**CERTIFICATE OF APPROPRIATENESS**

**Property:** 1232 Arlington Street, Lot 21, Block 190, Houston Heights Subdivision, City of Houston, Harris County, Texas. The site includes a 1½-story, 2,135 square foot residence situated on a 6,600 square foot (50' x 132') interior lot.

**Proposal:** Alteration – Remove an existing rear addition and construct a two-story 1,860 square foot addition with a 29' ridge height at the rear of a contributing structure. A previous Certificate of Appropriateness (COA) for a two-story addition was conditionally approved in October 2013. In addition to the proposed addition, the applicant proposes to:

**HAHC Action:** Approved

**WEST ELEVATION – FRONT FACING ARLINGTON STREET**

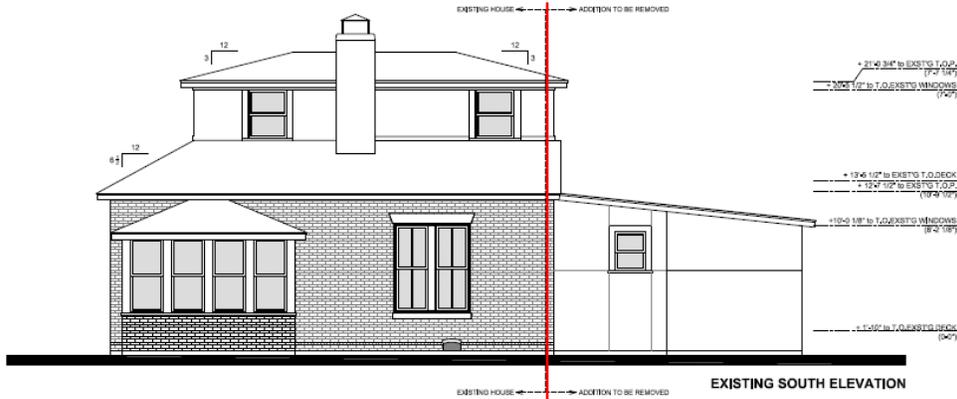
As part of the proposal, the existing pop-up addition roof will be removed and reconstructed at a steeper pitch. A railing will be installed between the existing porch columns. A portion of the one-story addition will be visible behind the southern previously constructed addition. The two-story addition will begin at the rear wall of the existing structure, behind the existing pop-up addition. The second-story of the addition will have a single 2-over-2 window on either side of the existing pop-up addition and will be topped by a hipped roof. The chimney will be removed. See drawings for more detail.

**SOUTH SIDE ELEVATION**

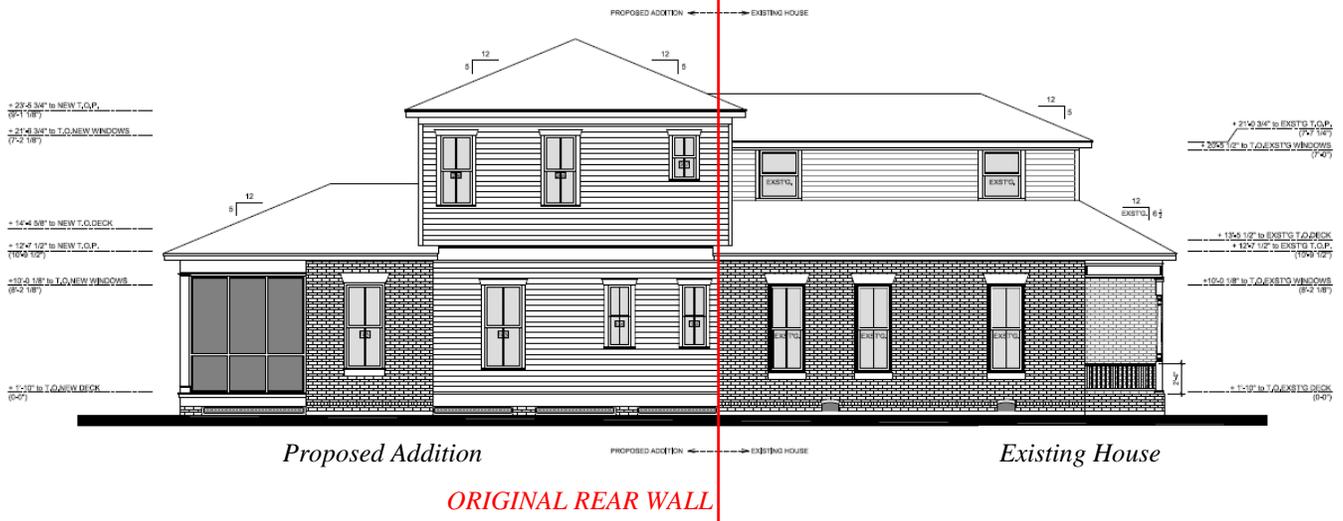
As part of the proposal, the existing pop-up addition roof will be removed and reconstructed at a steeper pitch. The existing rear addition will be removed and replaced by a two-story addition. The addition will begin at the rear wall of the existing brick veneer structure. The first-story of the addition will feature a brick veneer bump-out with two 2-over-2 windows. To the east, at the rear, a brick one-story portion of the addition will include a single 2-over-2 window. The rear of the addition will be a screened in porch. The second story will include three 2-over-2 windows and will be topped by a hipped roof. See drawings for more detail.

EAST (REAR) ELEVATION

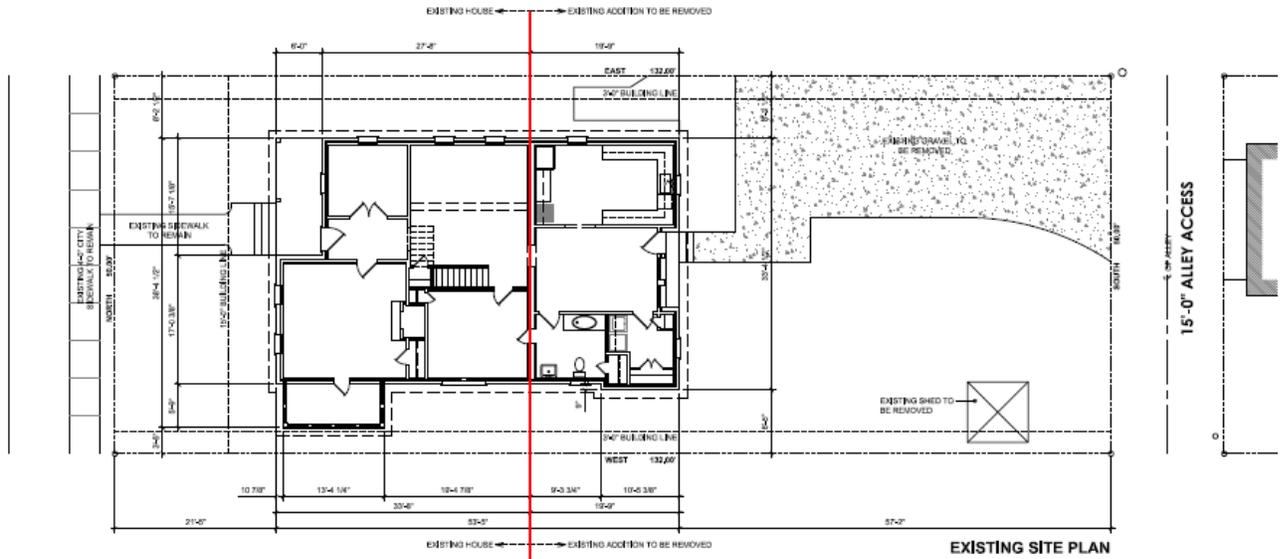
The rear is not visible from the public Right-of-Way. See elevation drawings for more detail.

**SITE PLAN  
 EXISTING**

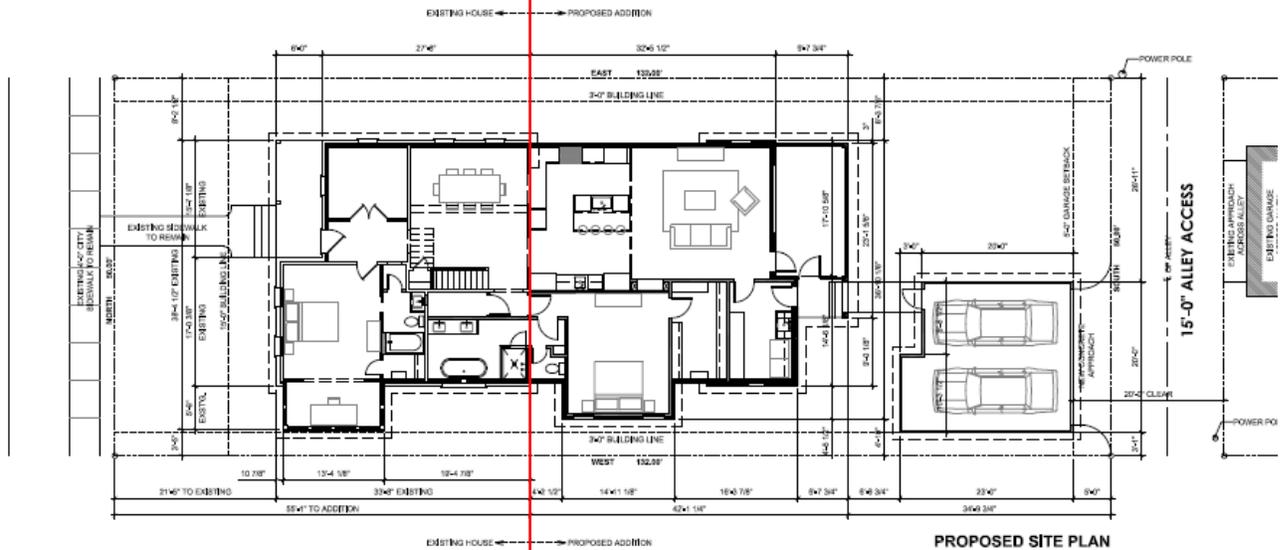
With the proposed addition, the front setback will be maintained while the north side setback will be 8'-4", the south side setback will be 4'- 5½", and the rear setback will be 34'-10". See drawings for more detail.

ROOF PLAN

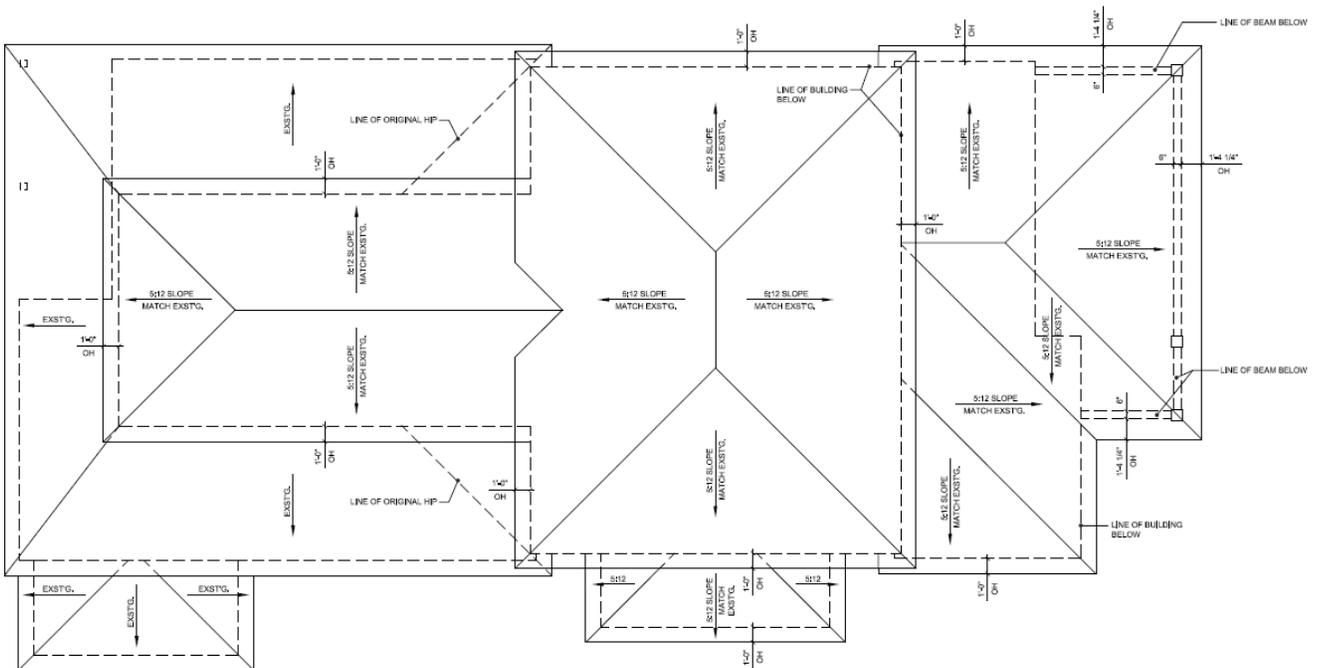
The existing roof of the pop-up will be replaced with a new roof with a 5:12 pitch to match the roof of the original structure. The proposed addition will have hipped composition shingle roof with a pitch of 5:12. See drawings for more detail.
